NUMBER: 18-003-17 REV. B

Engine Oil Viscosity Upgrade And Flash Enhancements

2016	(WK)	Jeep Grand Cherokee
2016	(DS)	RAM 1500 Pickup

Fig. 1 Cap Before Sticker Applied

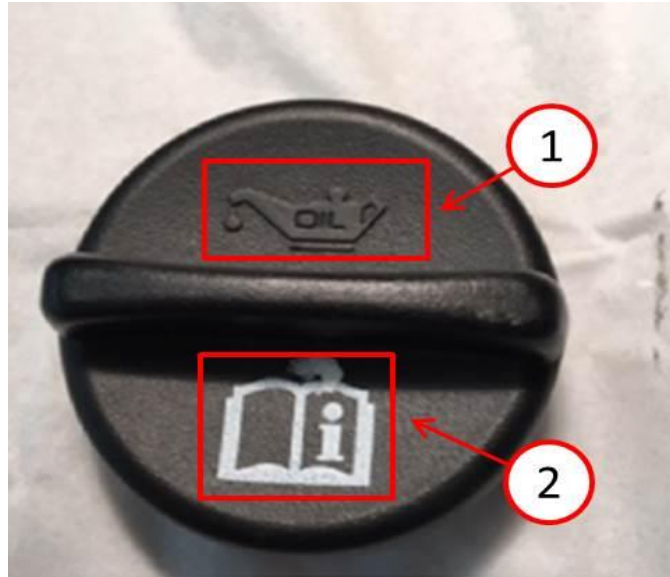
6. Remove oil fill cap.
7. Clean top of oil fill cap with Isopropyl alcohol or equivalent and apply engine oil viscosity rating sticker([Fig. 1](#)).

- 1 - Do Not Cover This Embossed International Oil Symbol
 - 2 - Cover This Old Oil Info Symbol With The New "5W40" Label
-
